DANE COUNTY DEPARTMENT of PUBLIC WORKS, HIGHWAY and TRANSPORTATION

RFB NO. 313083 - ADDENDUM NO. 3

CONSTRUCTION OF EAST HIGHWAY GARAGE – SALT STORAGE FACILITY (BID PACKAGE A) AND MEDICAL EXAMINER OFFICE BUILDING (BID PACKAGE B)

**DEPARTMENT OF PUBLIC WORKS,
HIGHWAY & TRANSPORTATION
3562 COUNTY HIGHWAY AB
MCFARLAND, WISCONSIN**

1 HVAC FIRST FLOOR PLAN
SCALE: 1/8"=1'-0"

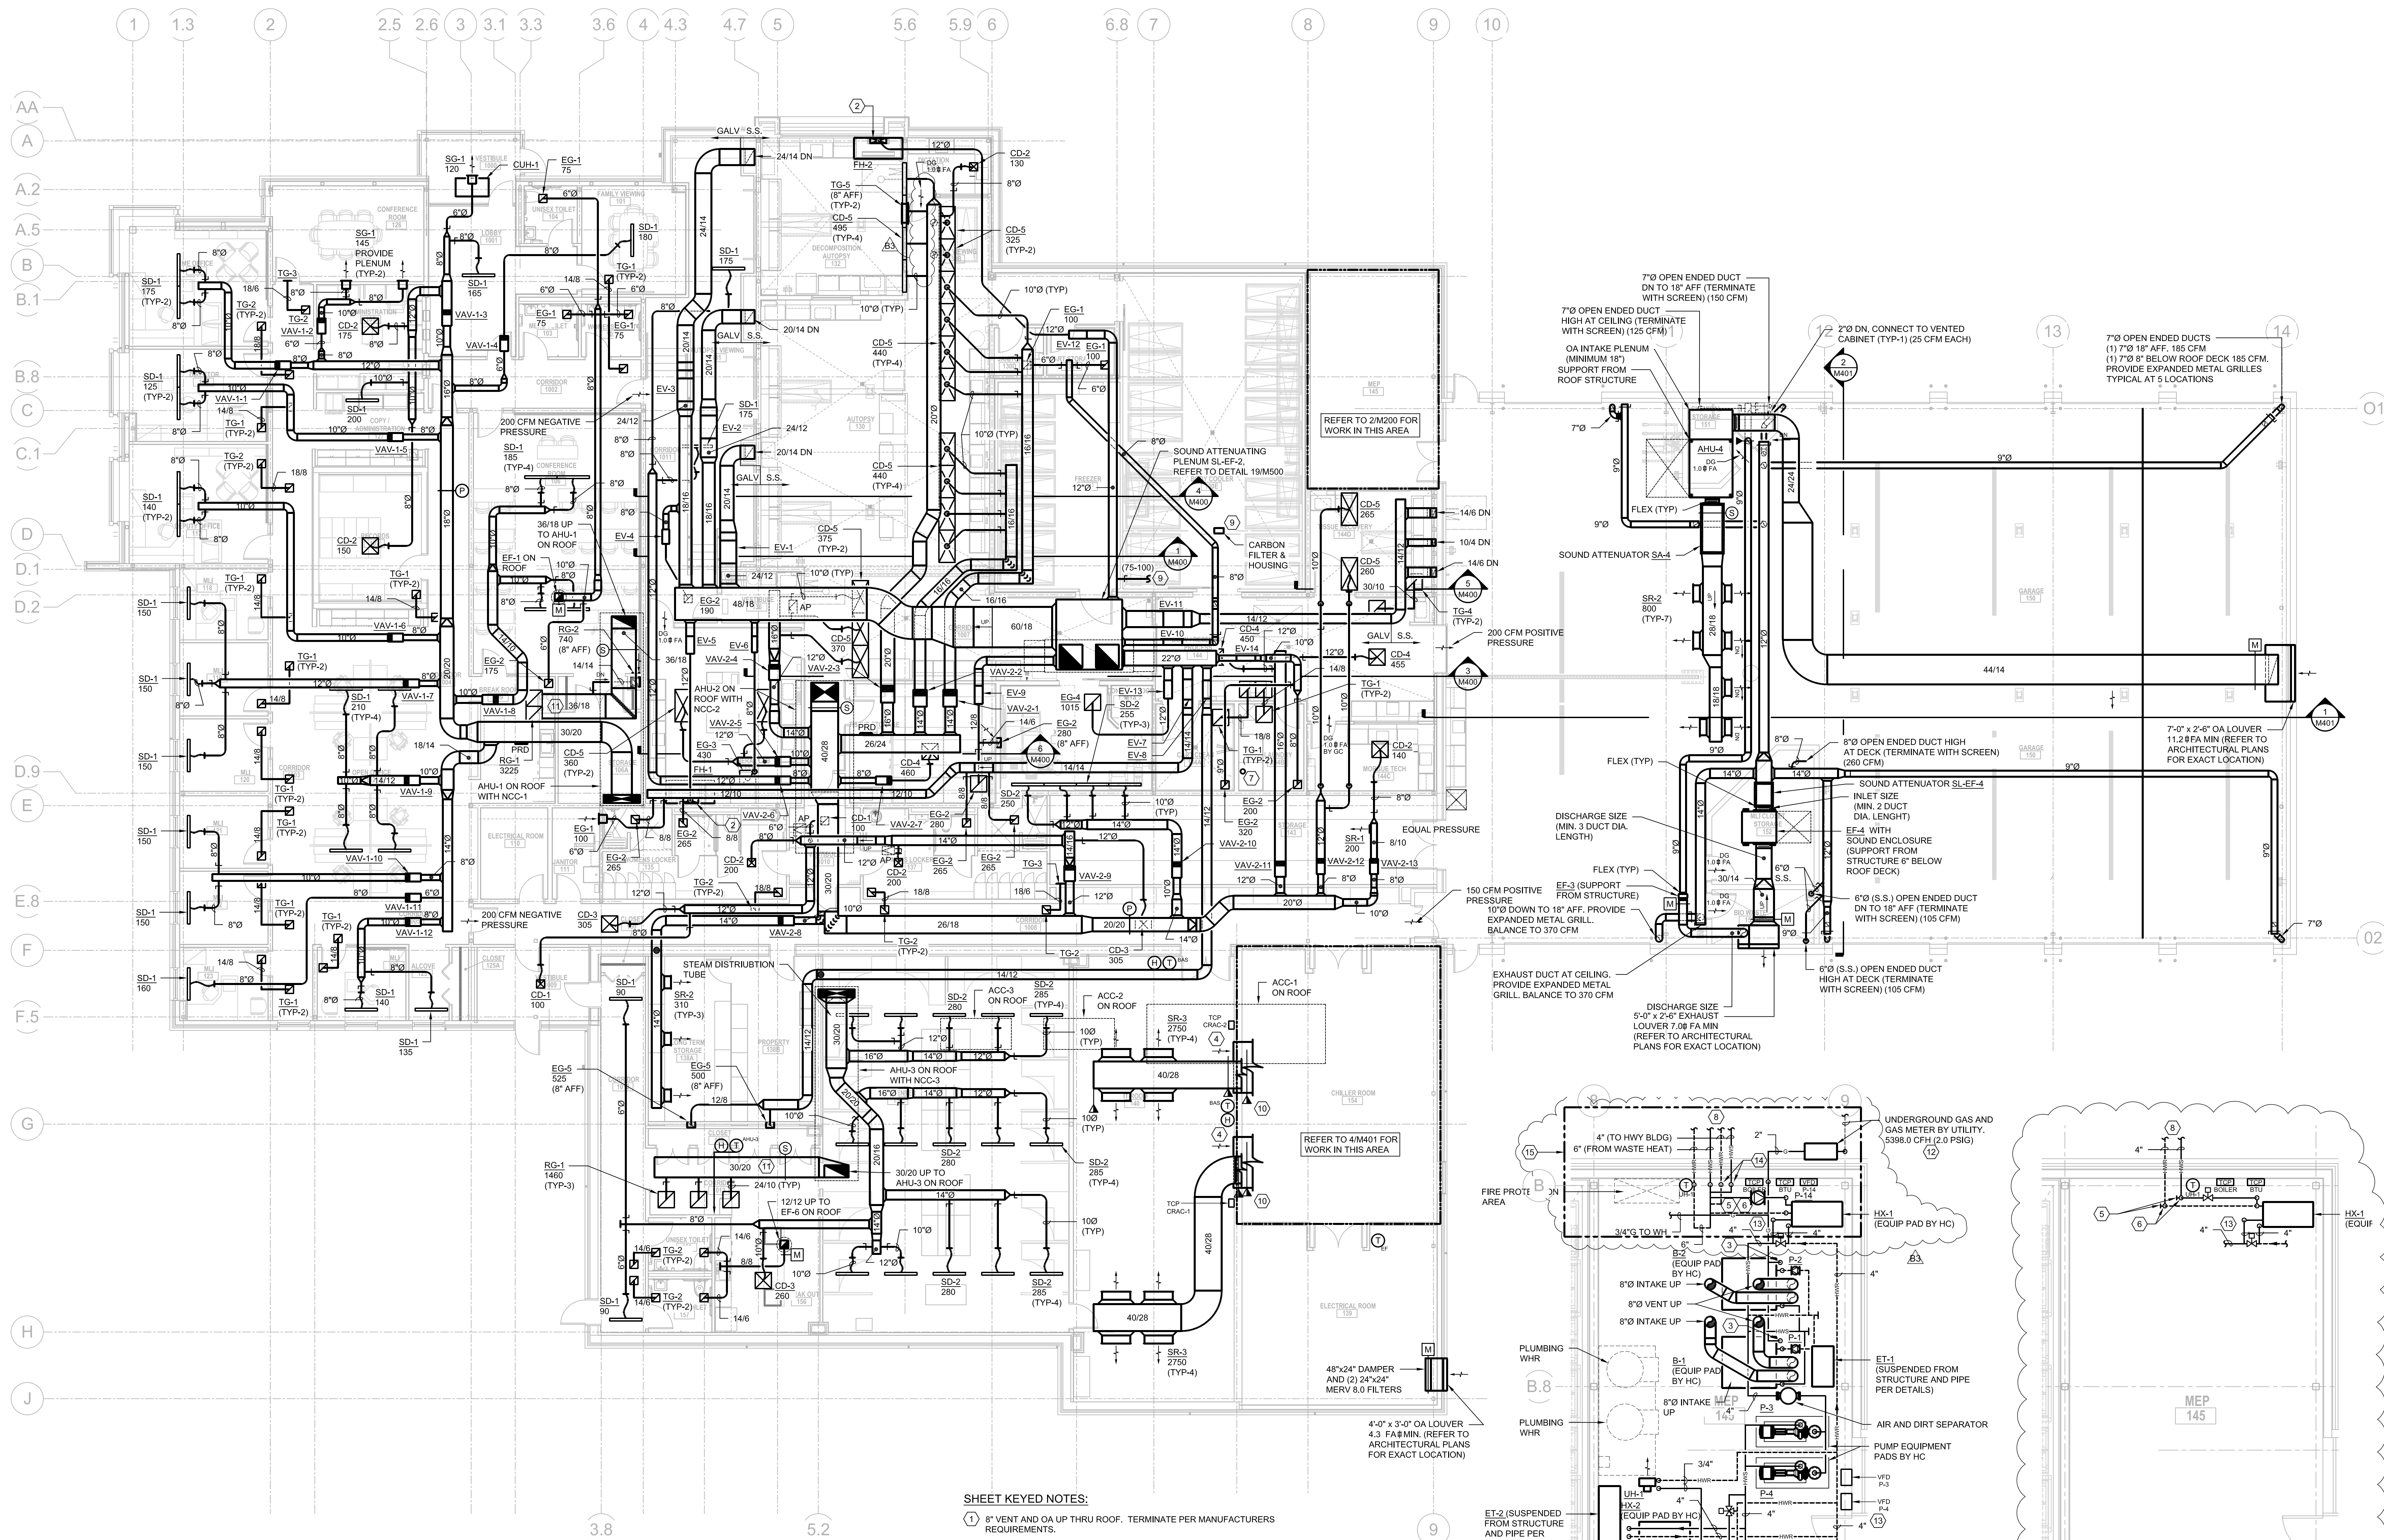
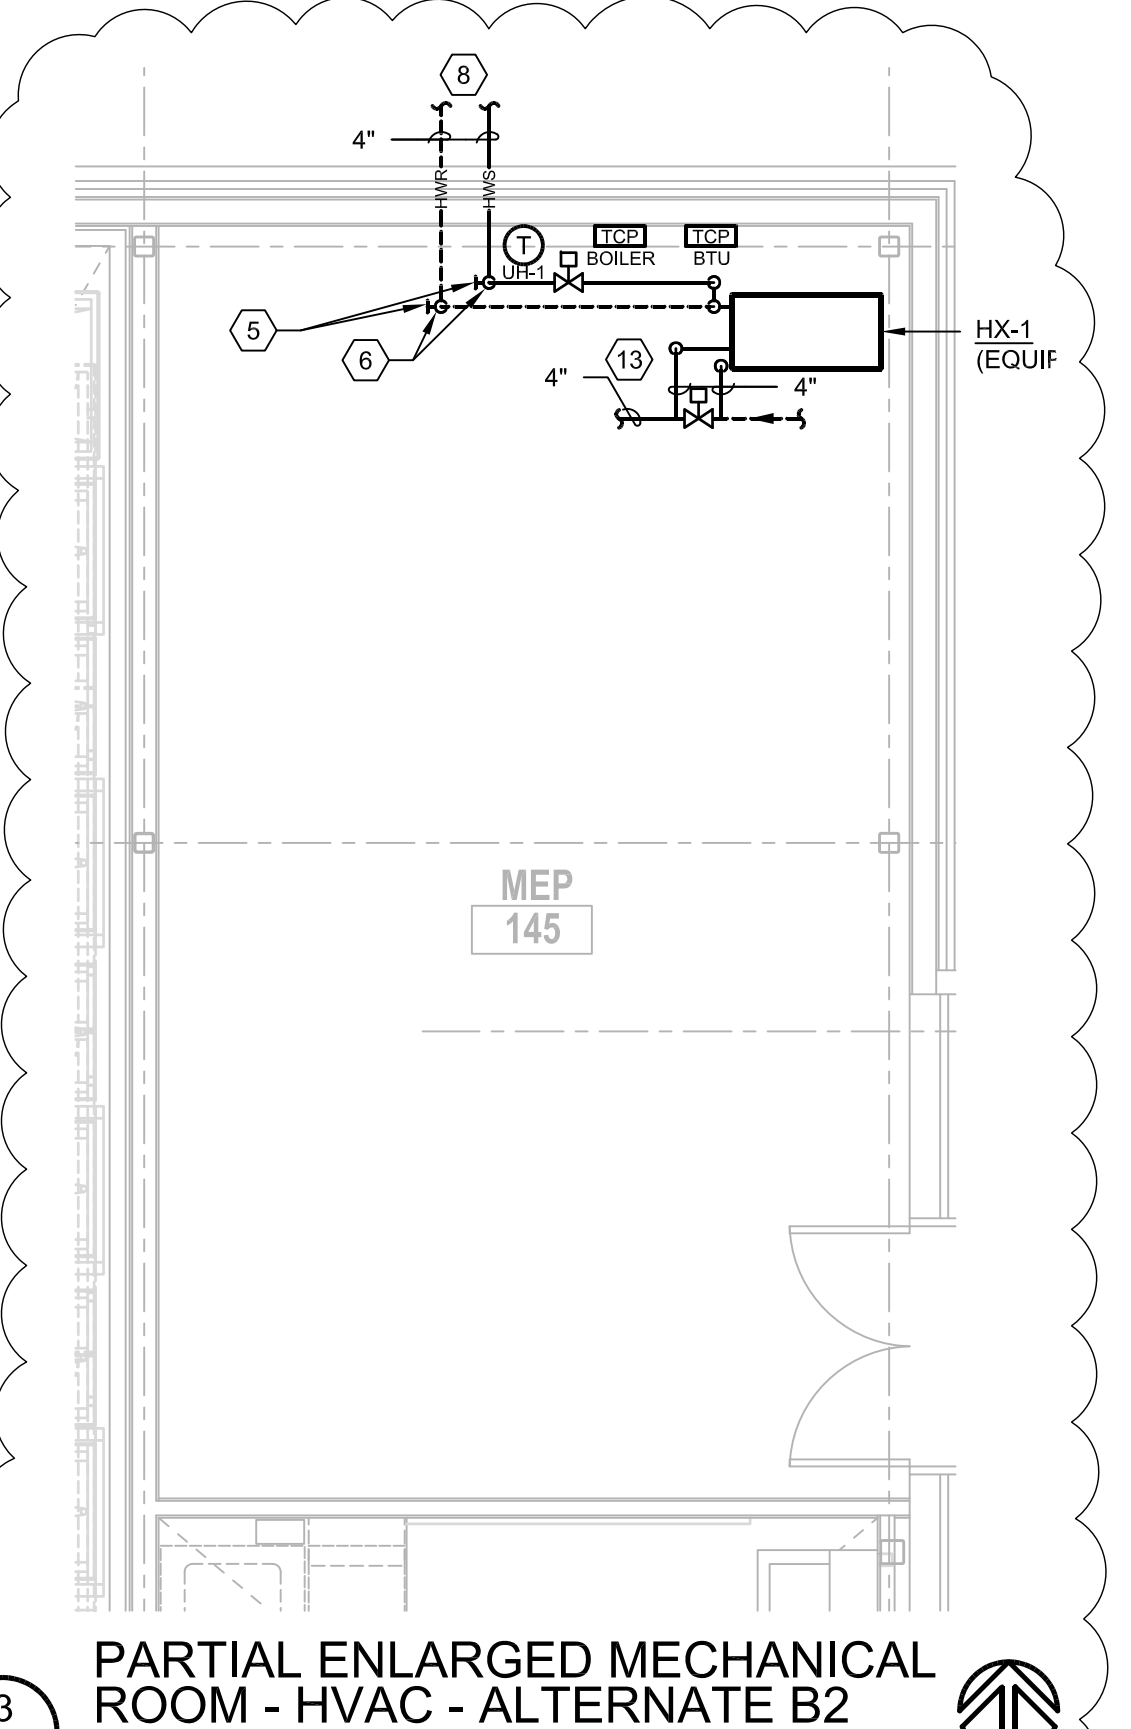
26. P200
 - a. Add garbage disposal (GD-1) at sink (S-1) in Break Room 109 and sink (S-1) in Break Out 156.
27. M200
 - a. Replace in it entirety.
 - b. Detail 1/M200 modified.

- c. Detail 2/M200 modified.
 - d. Detail 3/M200 added.
28. M300
 - a. Replace in it entirety.
 - b. Detail 1/M300 modified.
 - c. Detail 3/M300 added.
29. M800
